ZONING BOARD OF APPEALS MEETING

LOCATION: TOWNSHIP ANNEX, 7527 HIGHLAND ROAD, WHITE LAKE, MICHIGAN 48383
THURSDAY, MARCH 28, 2024 – 6:30 PM

RE: Ginko Self-Storage
Preliminary Site Plan and Special Land Use – Review #4

DRAWING TITLE
PRELIMINARY FLOOR PLAN AND BUILDING ELEVATIONS

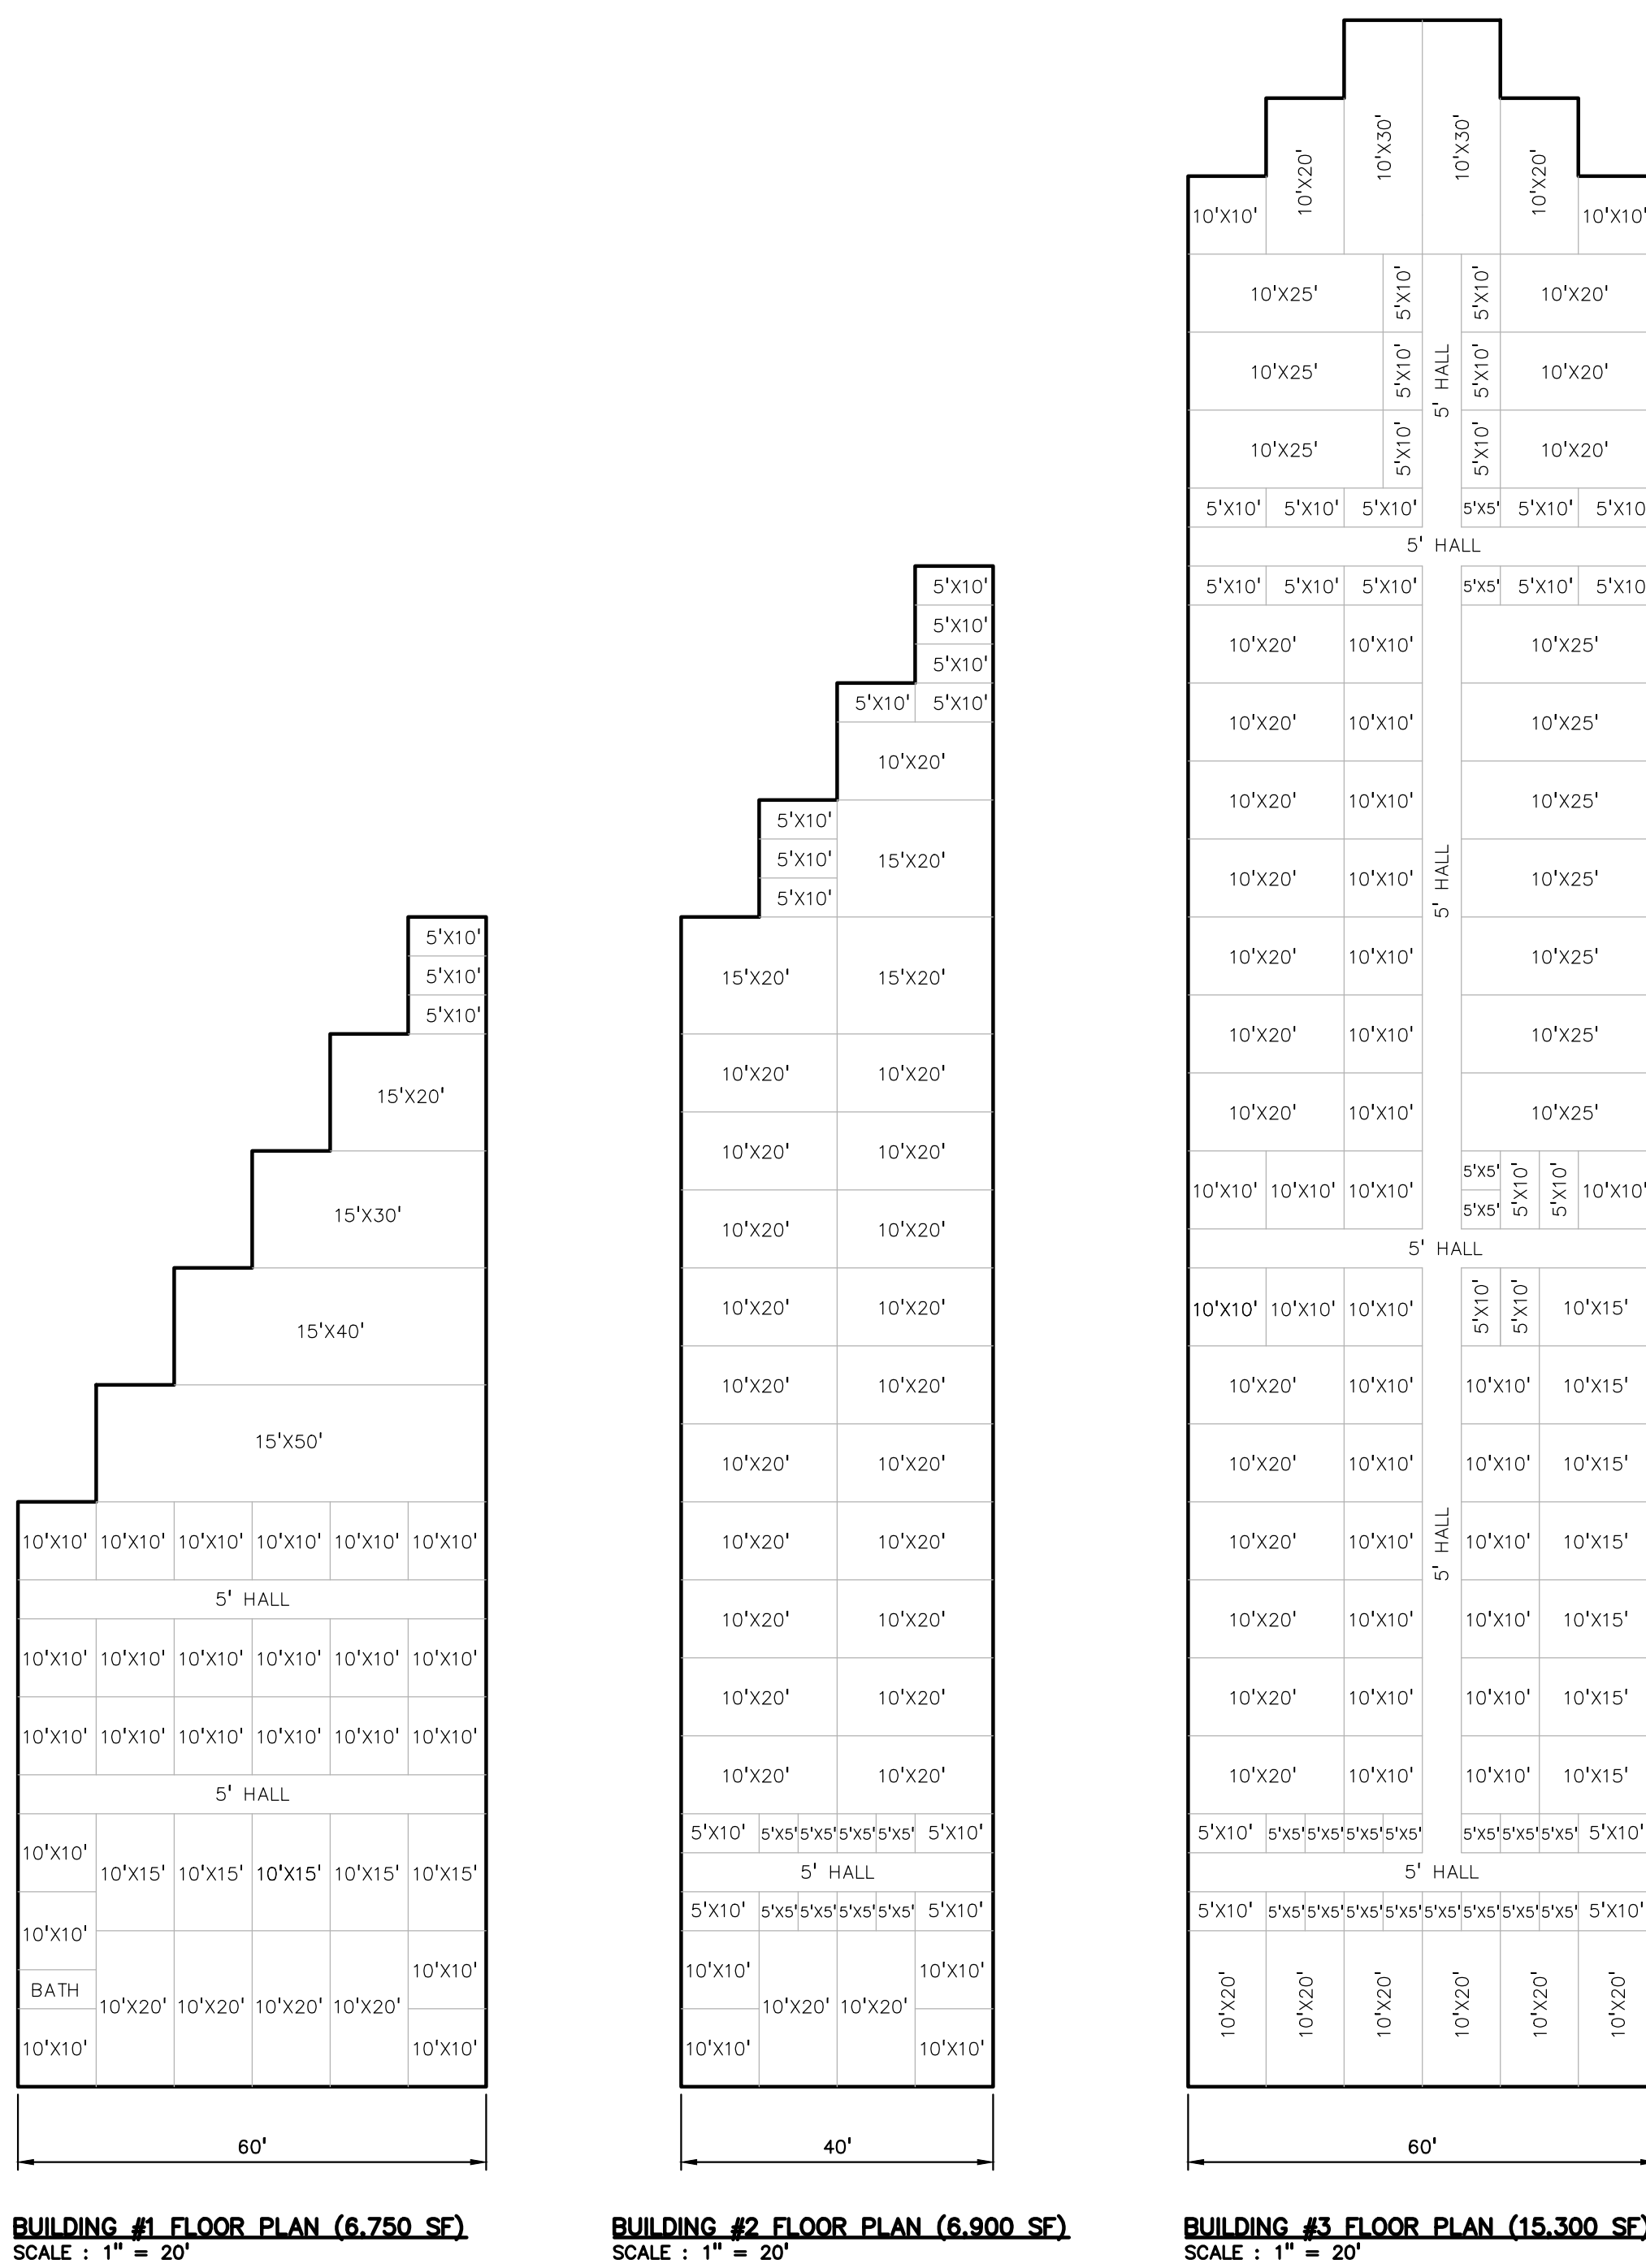
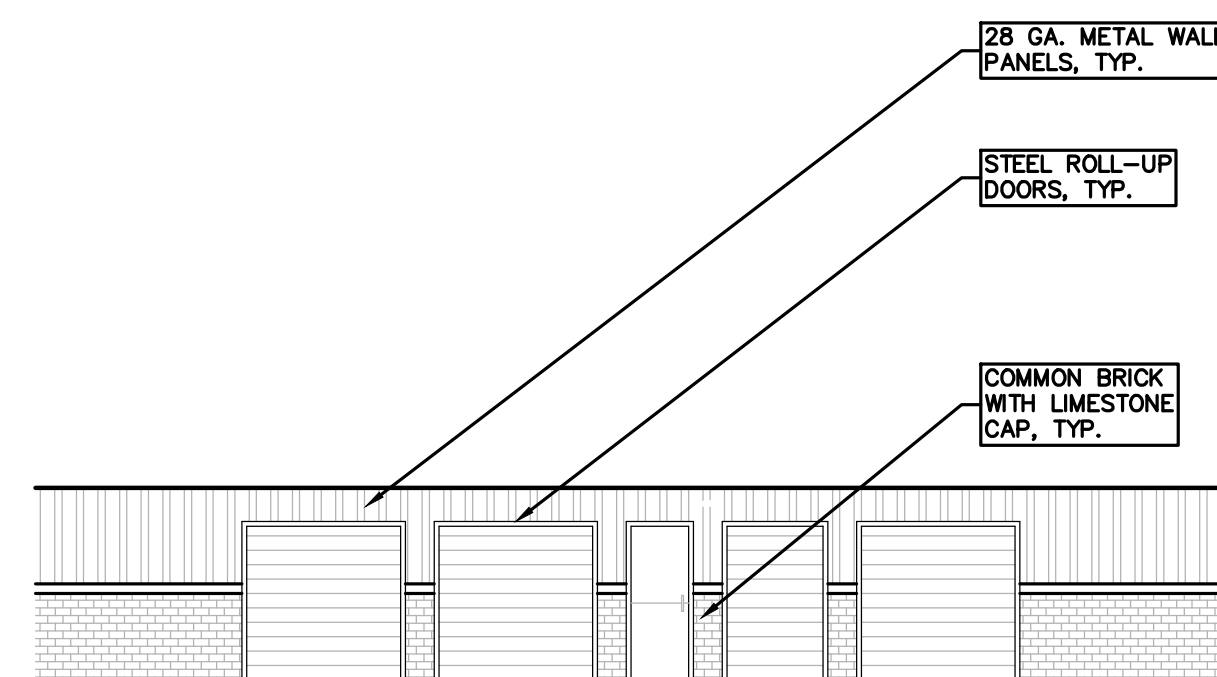
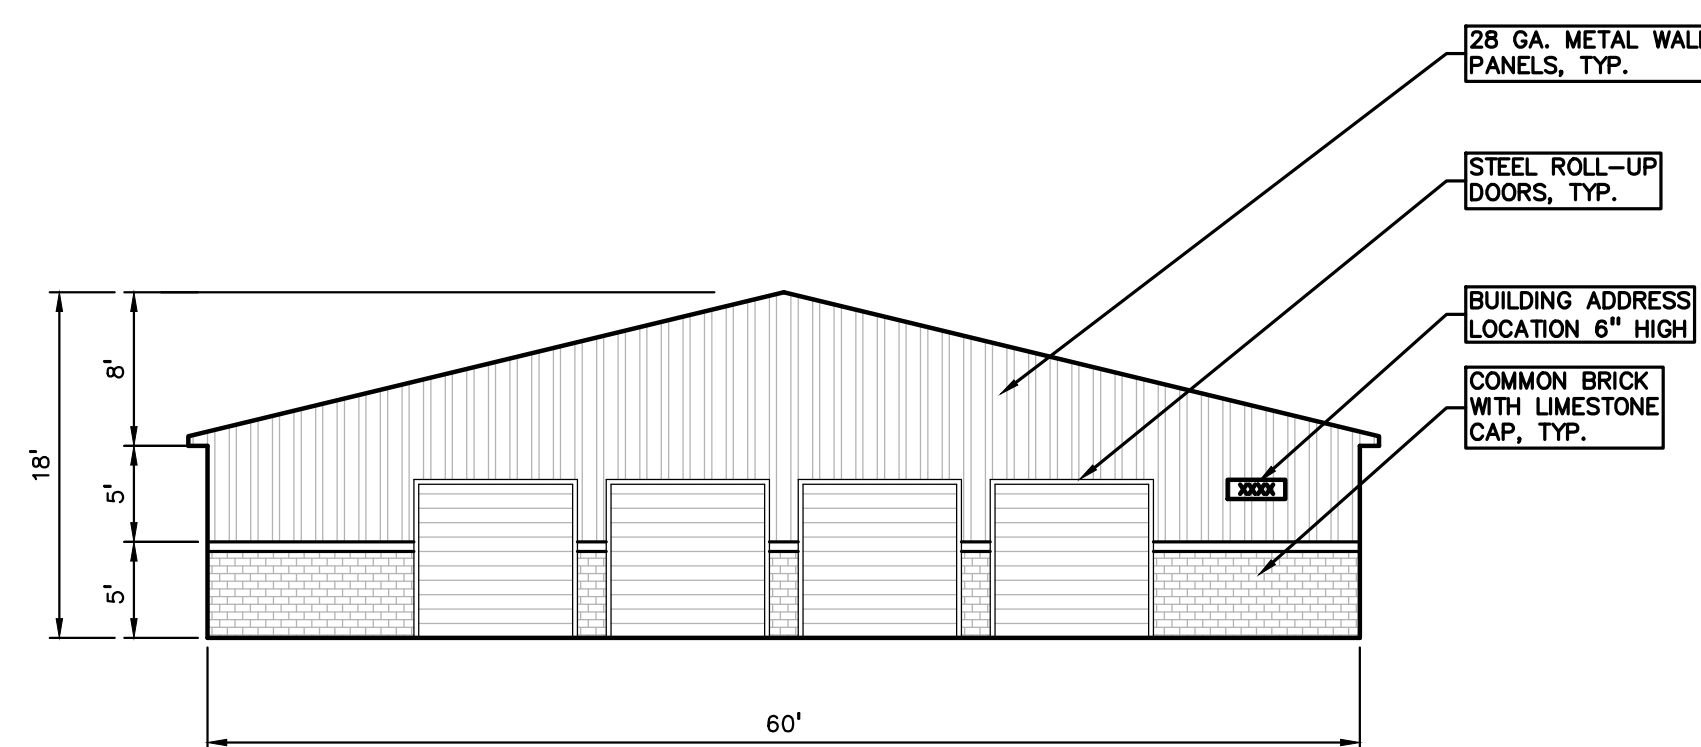
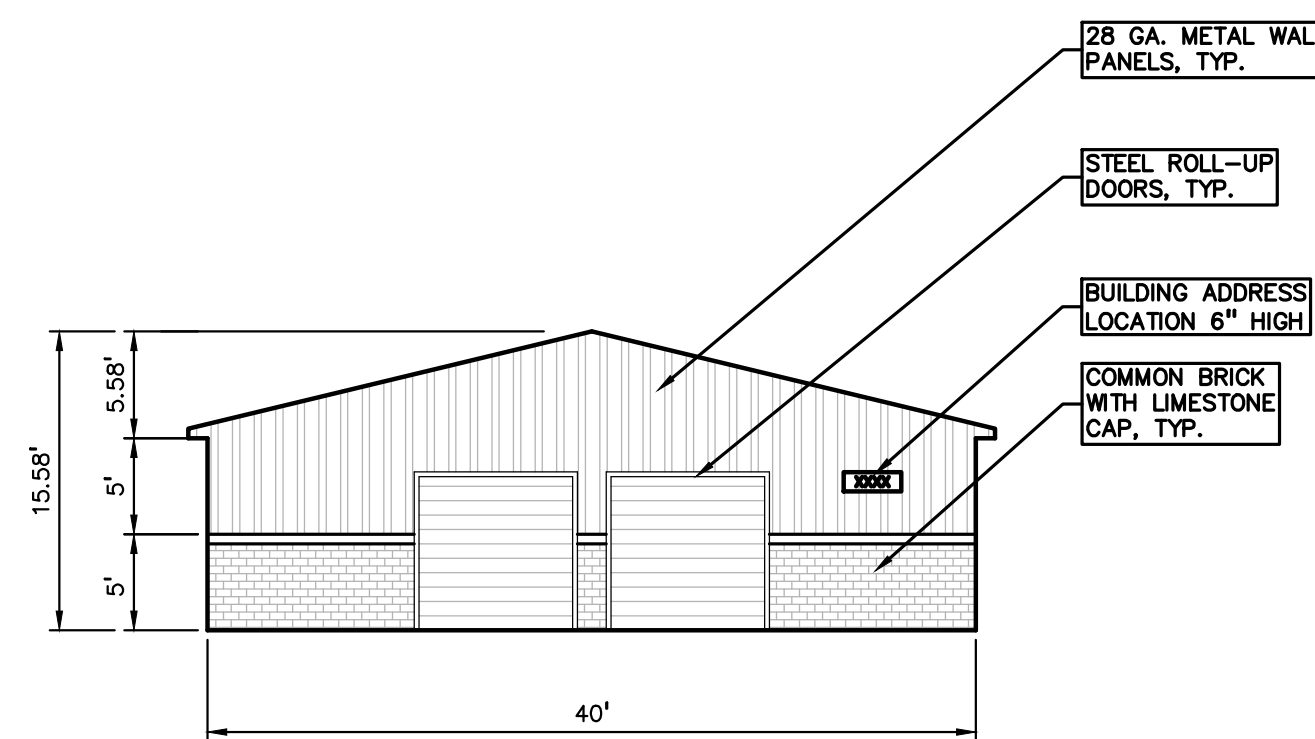
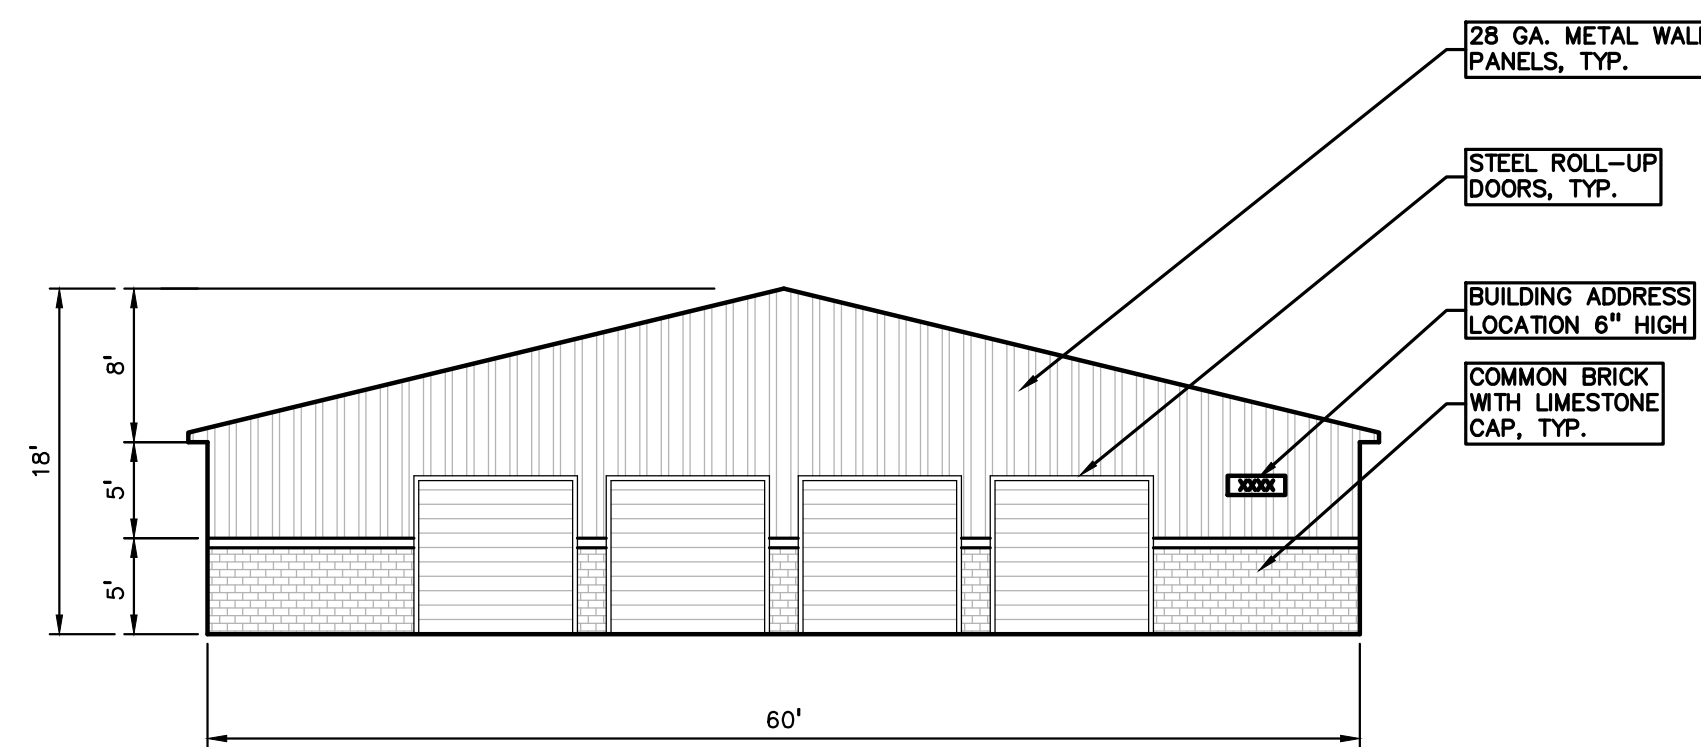
A sample board of building materials to be displayed at the Planning Commission meeting and elevations in color are required by the zoning ordinance and must be submitted at final site plan. Additionally, the address (street number) location shall be shown on the building. Six-inch-tall numbers visible from the street shall be required. The address locations are subject to approval of the Fire Marshal. (Comments remain as a notation). (Street number locations on the buildings are shown on Sheet A-1.0).
